**DOCKET****08-AFC-3**

RE: Marsh Landing Generating Station
Application for Certification 08-AFC-03

The Department of Toxic Substances Control (DTSC) has completed review of the March 2010 "Facility Investigation and Risk Assessment Workplan, Marsh Landing Generating Station, Mirant Contra Costa Power Plant, Contra Costa County, California" submitted by AMEC Geomatrix, Inc. of Oakland, CA on March 17, 2010. Enclosed please find our comments.

**REVISED INVESTIGATION AND
RISK ASSESSMENT WORK PLAN**

Figure **2**

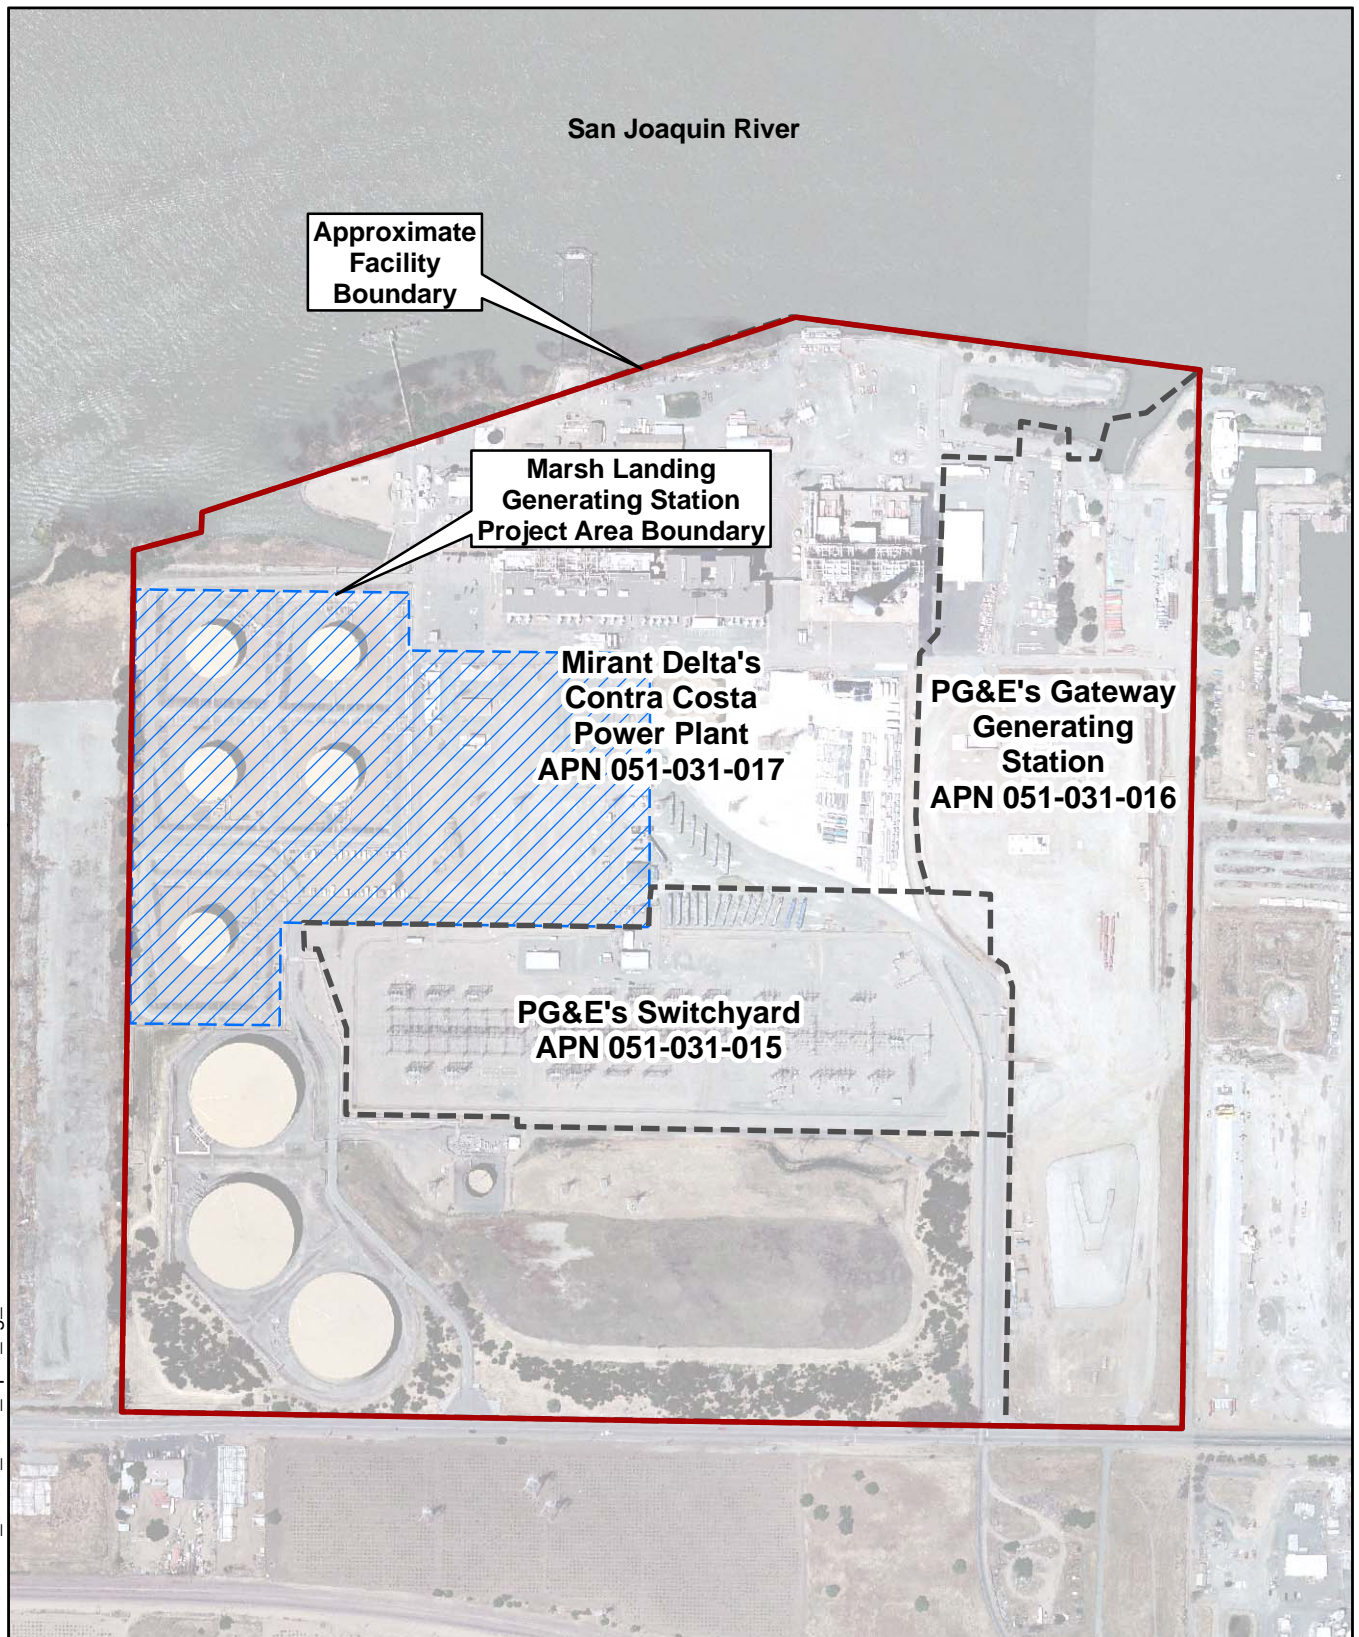
- c. Explain that The "entire facility" includes three parcels: The Mirant-owned parcel the Contra Costa Power Plant currently occupies, the parcel PG&E's Gateway Generating Station occupies, and the parcel PG&E's switchyard, or switching station as it is also known, occupies.

- e. Explain that the "Facility" is identified by Contra Costa County Assessor's Parcel Numbers (APN) 051-031-015, 051-031-016 and 051-031-017.
- f. Calculate the total area of the three parcels and provide this total area as the actual area of the facility.

The MLGS project area is within Mirant Delta's CCPP. The outlines of the MLGS project area boundary and the parcels that make up the CCPP Facility are shown in Figure 2. The project area is bounded by a former paperboard manufacturing facility to the west, the San Joaquin River and CCPP operational areas to the north, CCPP operational areas to the east, and a PG&E switchyard and a CCPP tank farm to the south (Figure 2). The surrounding land use is a mixture of industrial, commercial, and residential (URS, 2008).

October 1997 Water Level Data and Potentiometric Surface Map

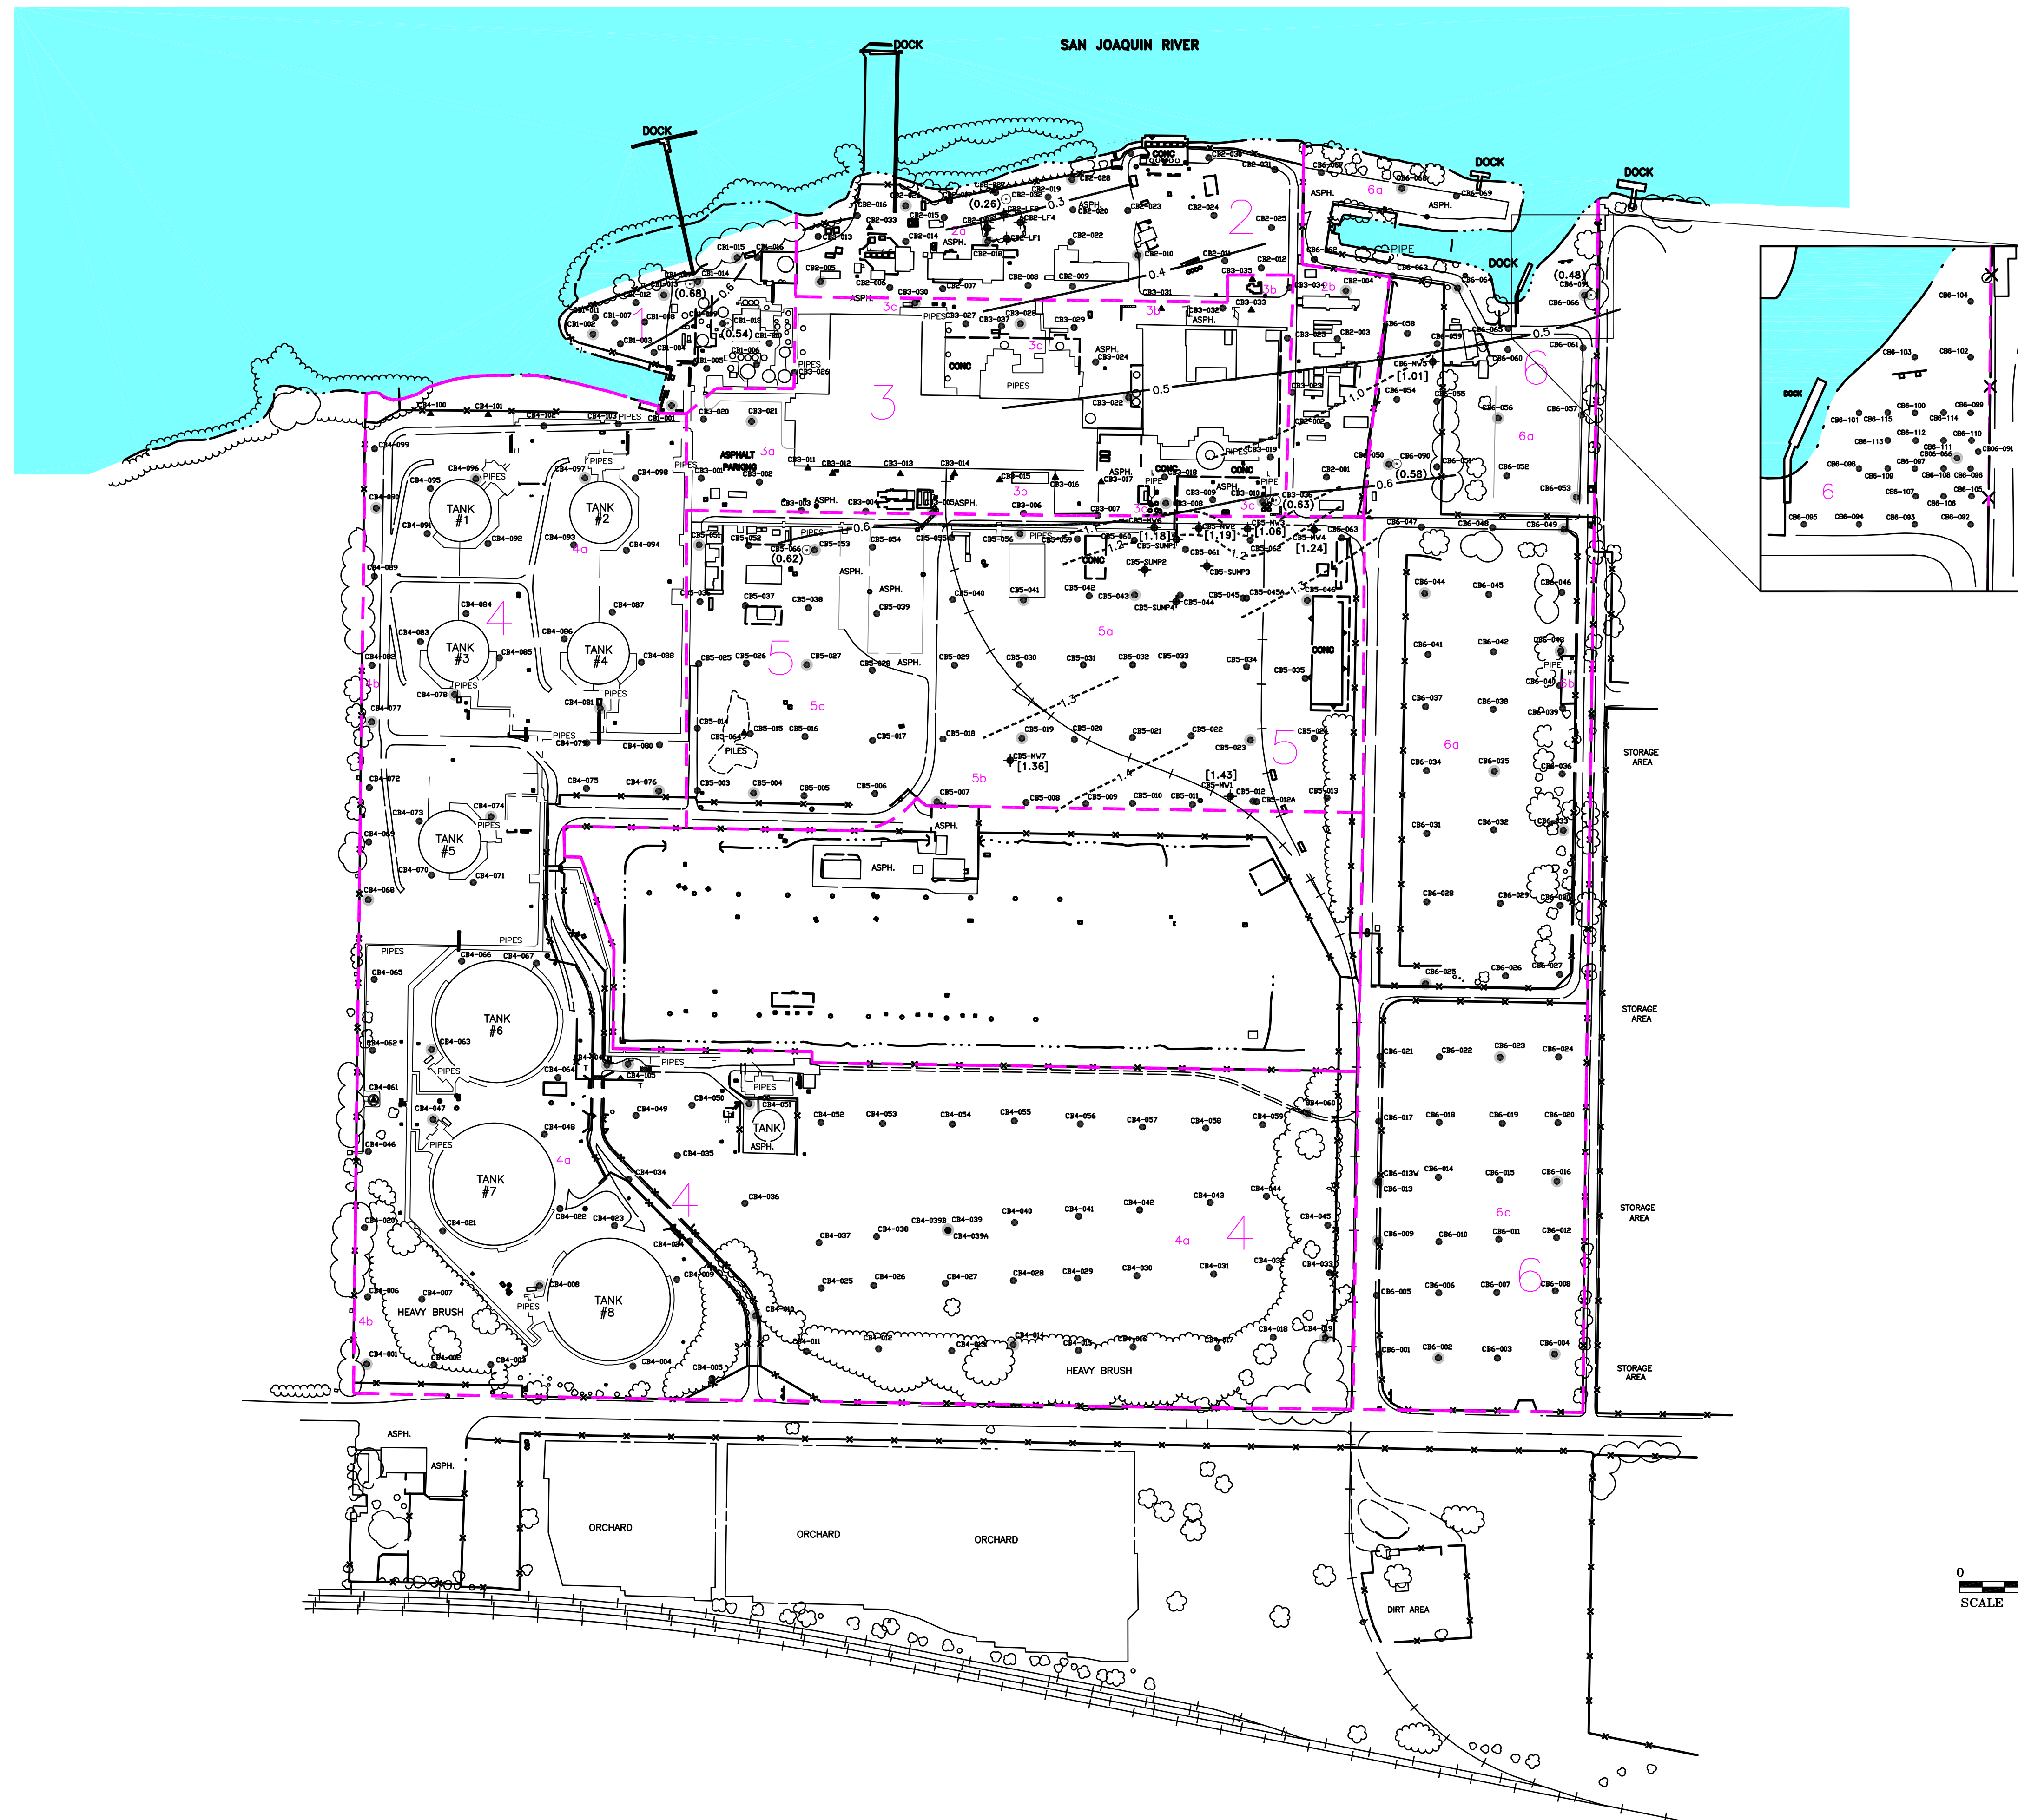
Although the groundwater flow direction and gradient across the project area was described in the workplan, include actual data and potentiometric or groundwater elevation contour maps in the report supporting these conclusions.
